CM05 Magnetic Separation Center Non Conformity

Sandor Feher – HL-LHC AUP L2 manager, Fermilab

CERN meeting – August 2nd, 2024

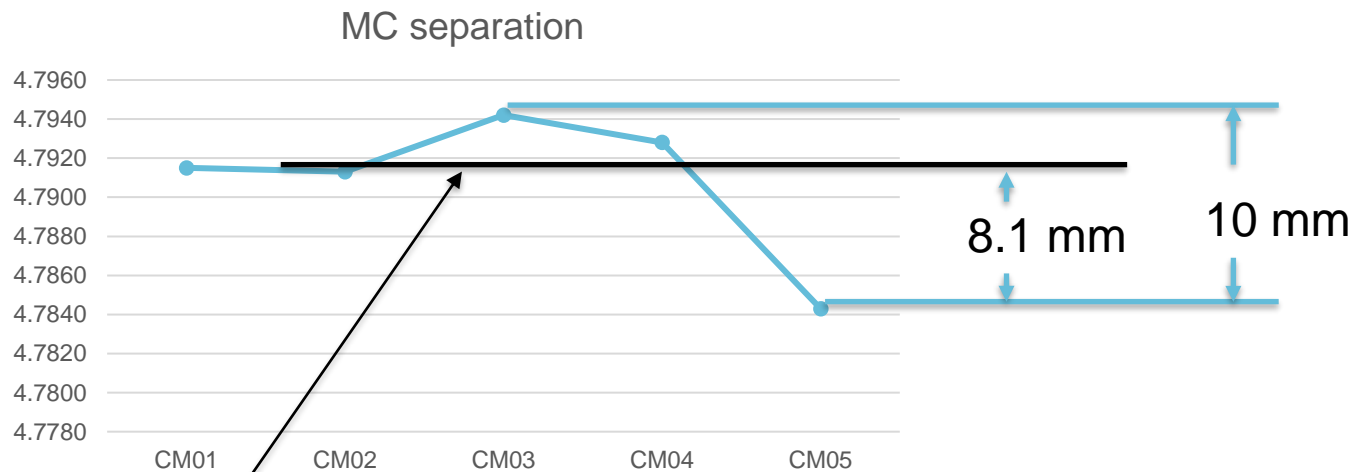
I updated the model. When uncompensated, the change in position of the halves of Q1 and Q3 cause a 7% beta* error. The optics was easily re-matched (still needing 7 steps due to the non-linear response of the quadrupole strengths) to restore the main features. The cost was only very small (the 3-4 units) increase in Q2/Q3 strengths for which there are margins and comparable variation in all nearby quadrupoles. The other figures of merit were kept basically constant.

This shows how sensitive is the optics to the model and that there is enough flexibility on small changes of design parameters. Again the priority should be reproducible features and accurate magnetic measurements. Updating the model on paper is easy, but with beam measurements 7 iterations may be prohibitive.

In conclusion we confirm that the change is acceptable.

MCS adjustment

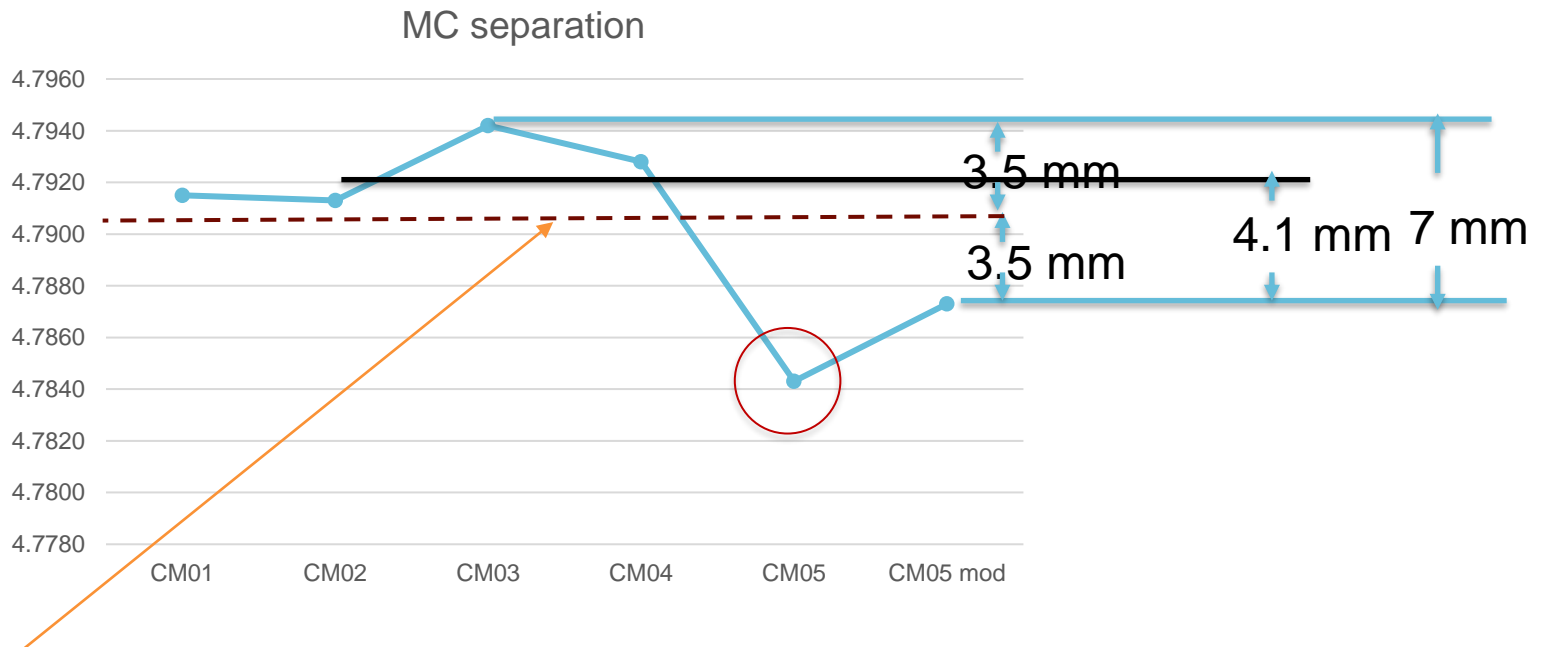
- There is a possibility to move CM05 magnets further apart by 3 mm

With the new target MCS value the CMS values for all magnets would be within ± 5 mm
